**INVITATION FOR BIDS (IFB) #25-019
EAST LAKE CLUBHOUSE APARTMENTS RENOVATION**

ADDENDUM NUMBER ONE (1)

ADDENDUM NO. ONE (1)

RE: Exterior Repairs at East Lake Club Apartments
150 East Lake Club Drive
Oldsmar, Florida 34677

4	NEW CONCRETE MOW STRIP AT CONDENSATE PIPE
A-505	NOT TO SCALE

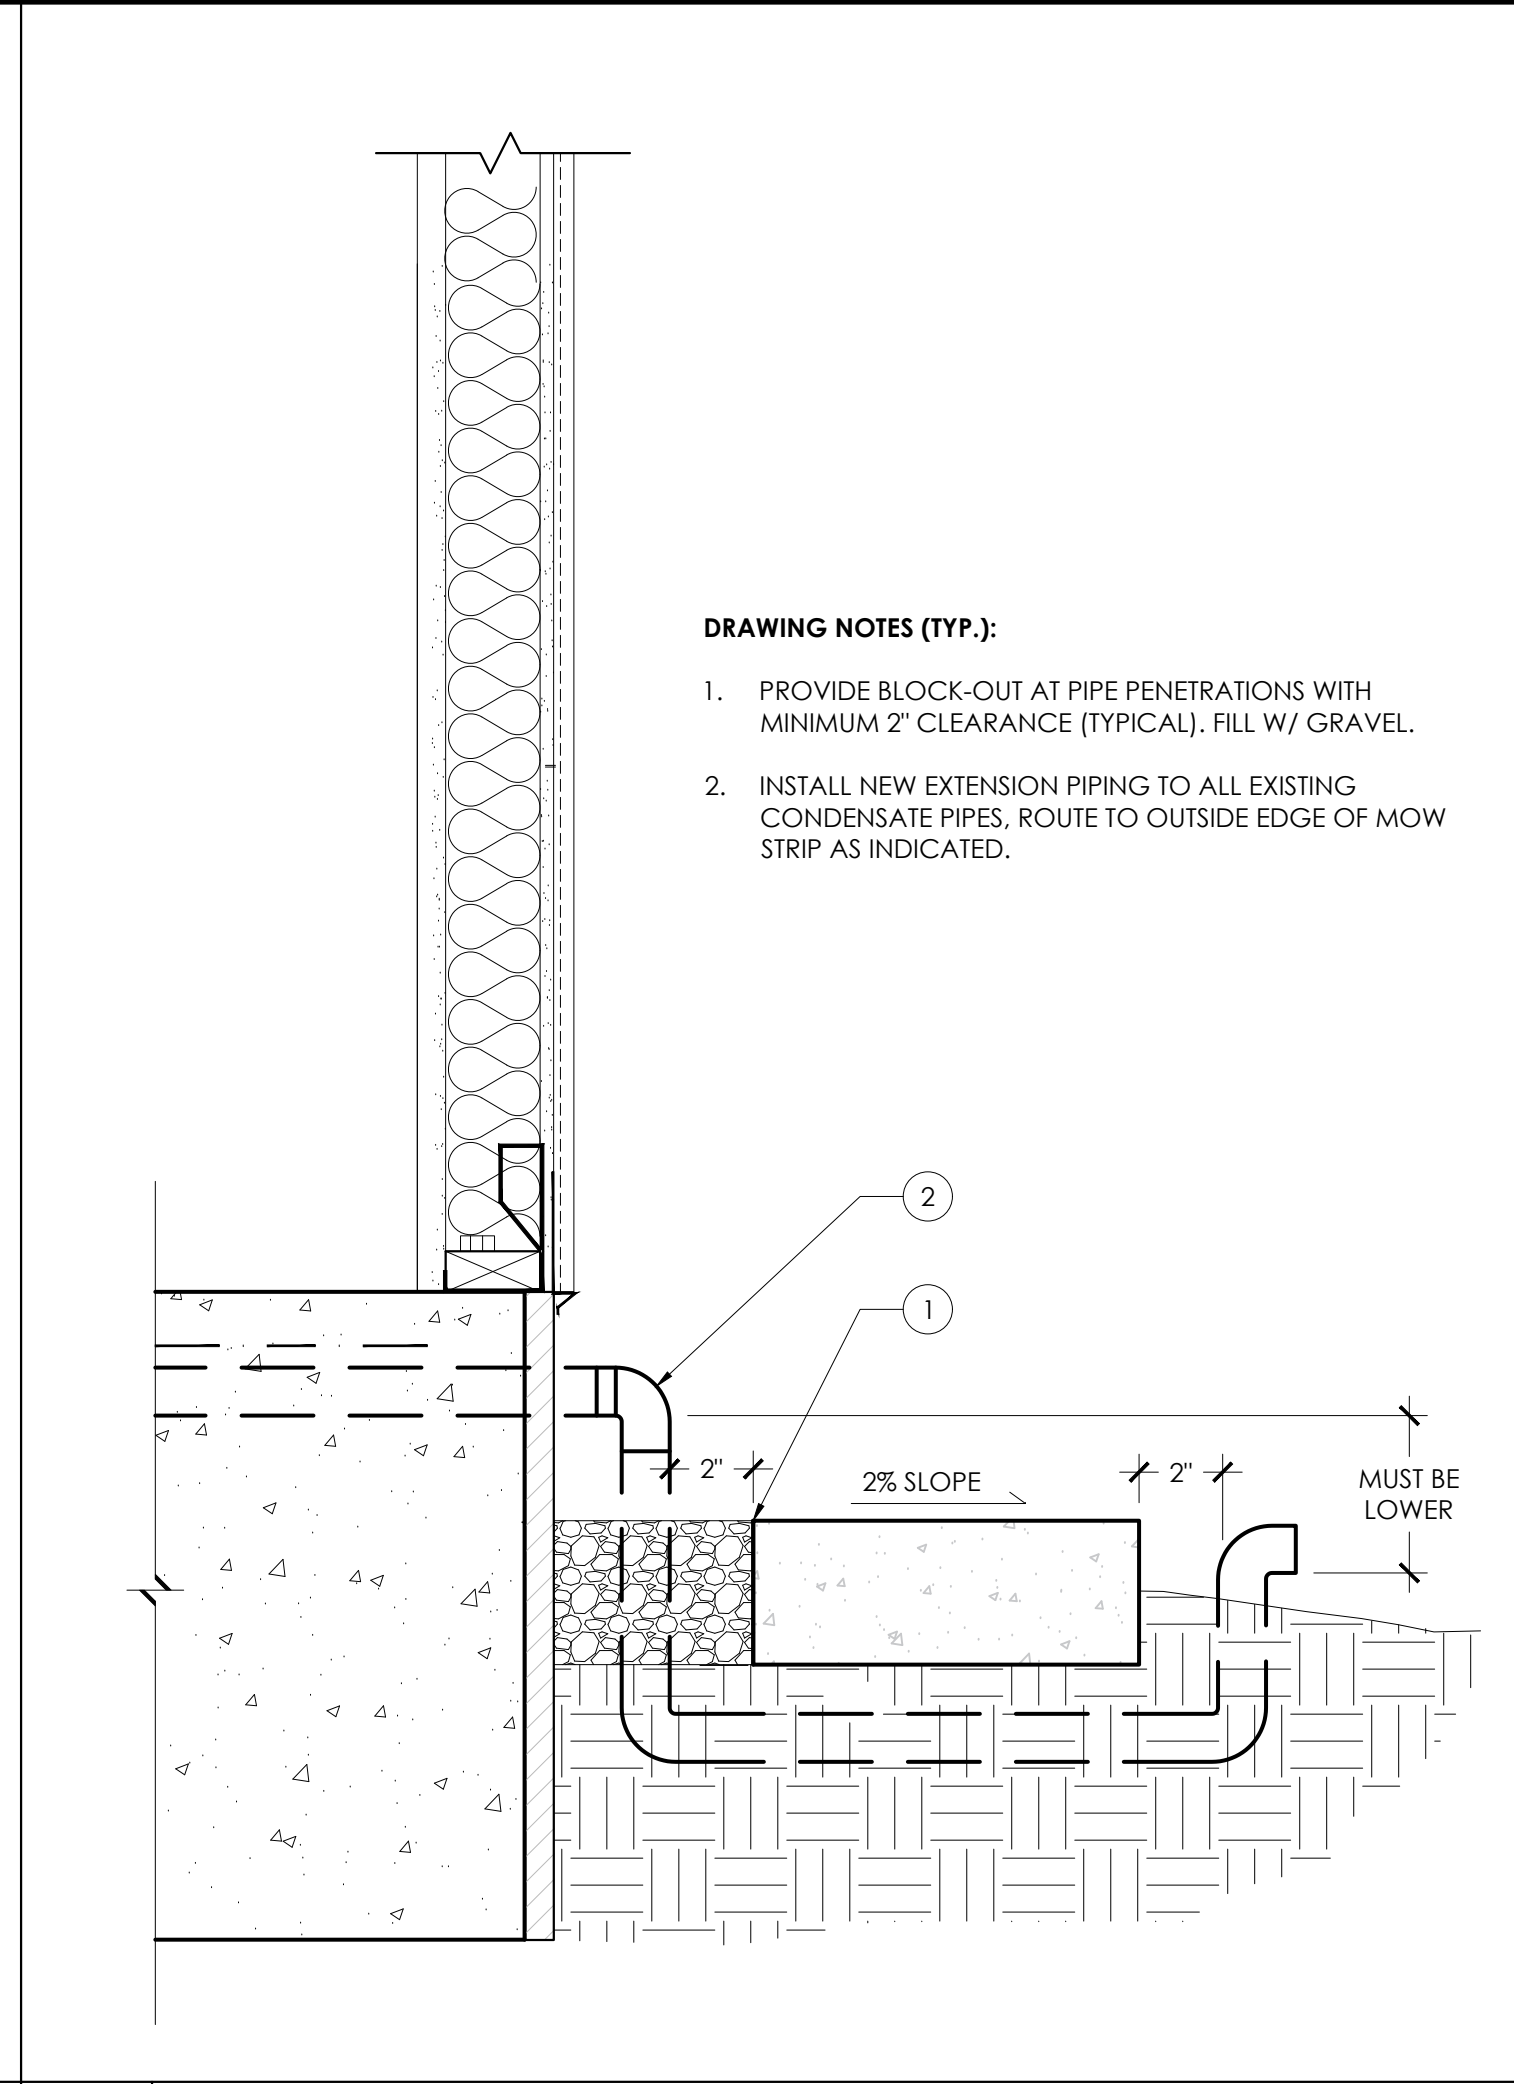
2. Refer to Specification Section 01 11 00, Para. 1.04.E.13; Revise Item 'b' to read as follows:
 - b. Rework grading, install gel patch along foundation wall, and install new concrete mow strip per Details on Sheet A-505. Document, remove, salvage, and store any irrigation items (e.g. piping, sprinkler heads) in area of new mow strip for future modification/reinstallation.
3. Refer to Section 01 11 00, Para. 1.04.E.14.b which states, "Temporarily remove light fixtures and/or ceiling fans at patio ceilings to be restored, save for reuse. Reinstall after painting work is completed. Electrical work to be performed by Florida licensed electrician." This is a general note and would only apply where ceiling fans or lights are present. After review of the existing conditions, there does not appear to be any electrical fixtures at the end balconies.

5. Refer to Drawing Sheet A-502R1; Revised and enclosed.
6. Refer to Drawing Sheet A-503 and A-504, Detail 2; Contractor to remove existing marble sill (clean and save for reuse) and reinstall after installation of new window.
7. Refer to Drawing Sheet A-503 and A-504, Detail 2, Notes 7 and 19; The intent of the documents is to repair all new finishes. Contractor to match existing colors and assume in the bid proposal that paint will blend into existing paint finishes no less than 12-inches from the area of work.
8. Refer to Drawing Sheet A-505R1; Revised and enclosed.
